REMARKS

This submission is in response to the Official Action dated April 12, 2002.

Serial No. 09/888.073

PRESS MACHINE For:

Fig. 2

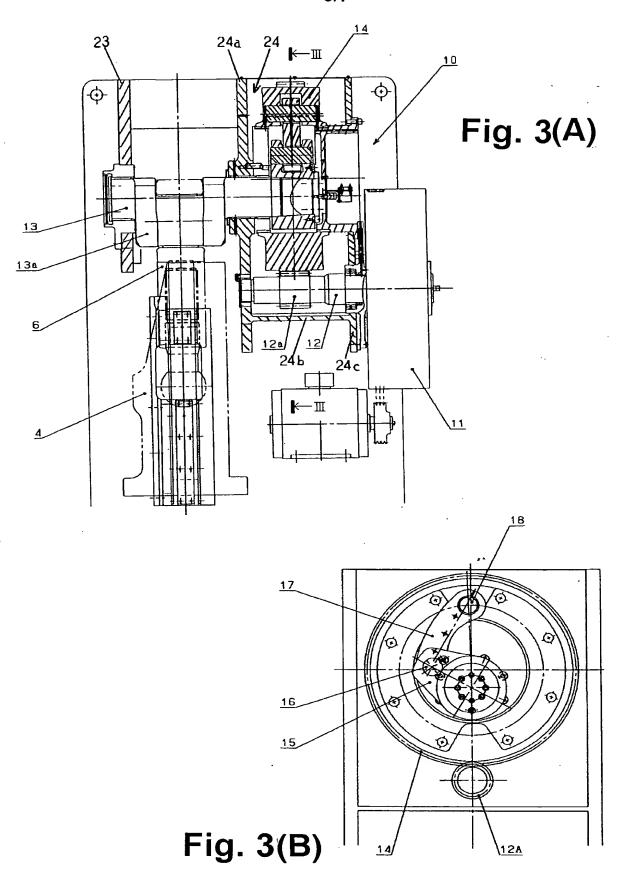
Regarding the first and second sides of slide 4, these are positional items and

are clearly shown in Fig. 2 on opposite sides of slide 4. Regarding the first and second

slide side gib, these are slide side gibs 4a, shown in Fig. 2 and described on page 11 lines

20-end. Regarding first, second and third mating surfaces, these are enabled and shown

as being on each respective first and second slide side gibs 4a. These mating surfaces

match respective front, side and rear liners 3a,3b, and 3c, as shown in Fig. 2 and

Regarding the "first centerline" see Fig. 2, identifying the previously shown

centerline. Regarding the "second centerline" see Fig. 2, identifying the previously shown

Reference to 'first, second, and third mating surface' has been clarified in the specification as shown and their inter-relationship with respective front, side, and rear liners 3a, 3b, and 3c. The particular surfaces are shown in Fig. 2. Applicants propose that the amendments to the specification have clarified any possible confusion in this matter and request the Examiner's reconsideration.

Cross sections 2a, 2b, 2c, and 2d are symmetrical to a first center line (vertical centerline

of press 1) and symmetrical to a second center line (horizontal centerline of press 1), both

shown on Fig. 2. During operation, press 1 may expand or contract due to operational and

Fig. 3(C)

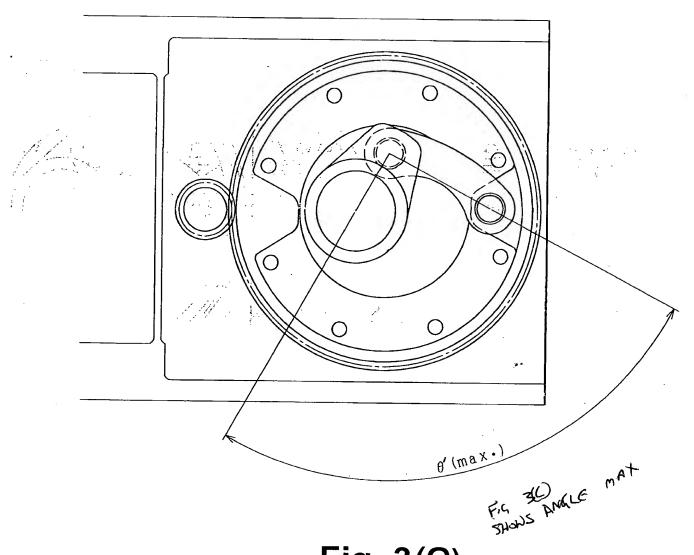
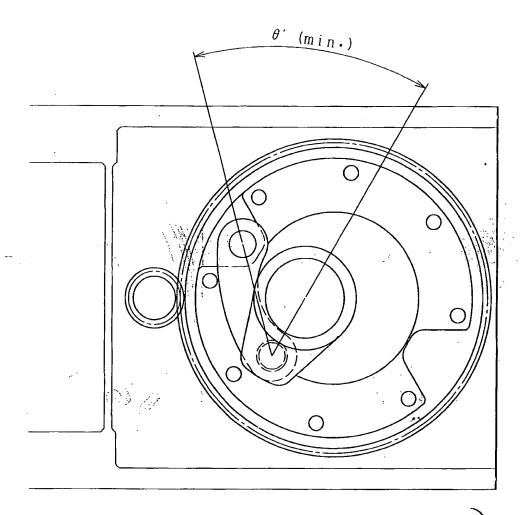
Regarding the requirement to show angles theta θ (and its variants)

editorial clarity only. Reference in claim 3 and 8 to "a first angle" remain for simplicity. The

"first angle" is supported on page 14, lines 18-21 and is shown as angle theta' (θ') in Figs.

Additionally referring now to Figs. 3(C) and 3(D), [A]an inner angle theta' (θ') (a first

angle) is defined [(not shown)] between first link 15 and second link 17. Inner angle theta'

(θ') , changes through the rotation of main gear 14 between an opening position at the

bottom dead center position and a closing position at the top dead center position, as
